# Requests for Adoption

IEEE 802.3dd – Power over Data Lines of Single  
Pair Ethernet (Maintenance #17) Task Force

May 25, 2021

Technical, 802.3bu, Page 53, Figure 104-8

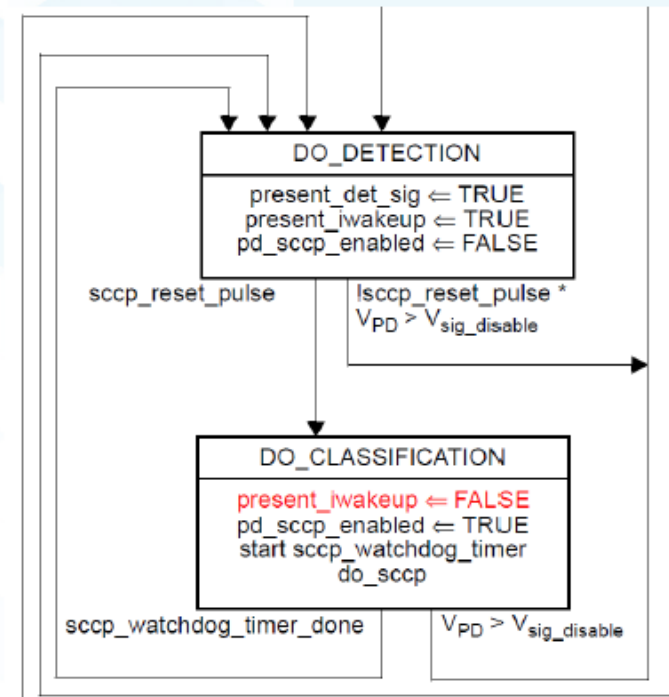
The PD state machine, as written, requires present\_iwakeup to be TRUE in DO\_CLASSIFICATION based on an assignment derived from DO\_DETECTION. During classification the PD is engaged in SCCP signaling and cannot simultaneously present the iwakeup signature.

Modify Figure 104-8 as follows, specifically setting present\_iwakeup to FALSE in DO\_CLASSIFICATION.

Technical, 802.3bu, Page 53, Figure 104-8

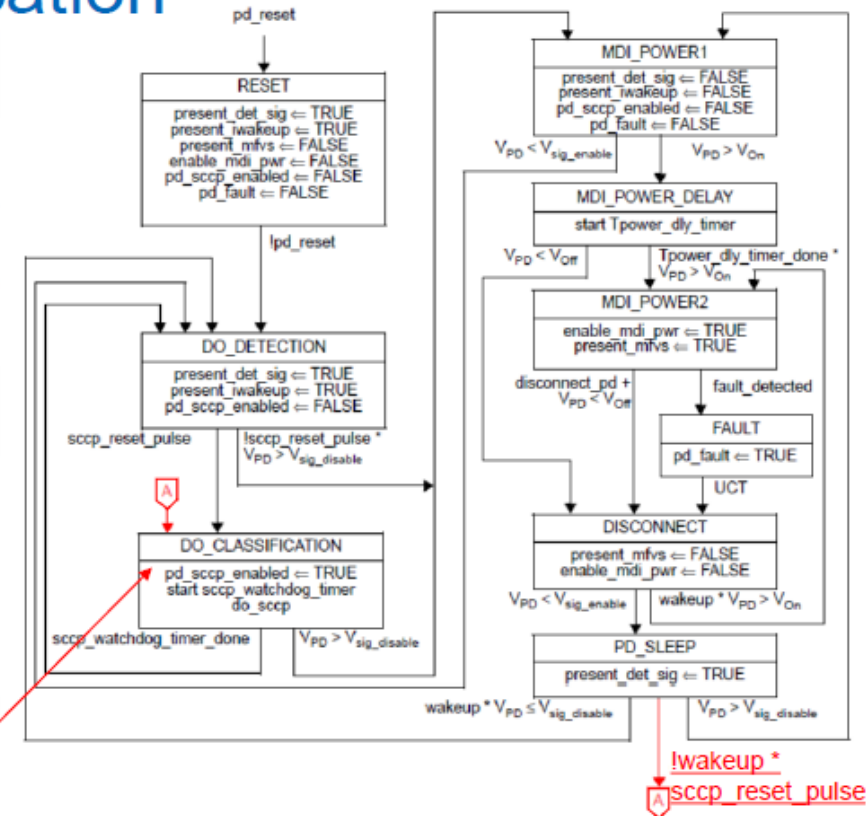
The PD state machine, as written, does not allow a PD to respond to SCCP classification on PD\_SLEEP exit.

Change

To

wakeup

An implementation specific variable enabling the PD to request wakeup.

TRUE: the PD requires the full operating voltage at the PI.

FALSE: the PD is ready to go to sleep or is not otherwise requesting full operating voltage.

4/27/21 proposed add:  
present\_wakeup <= FALSE

!wakeup \*  
sccp\_reset\_pulse
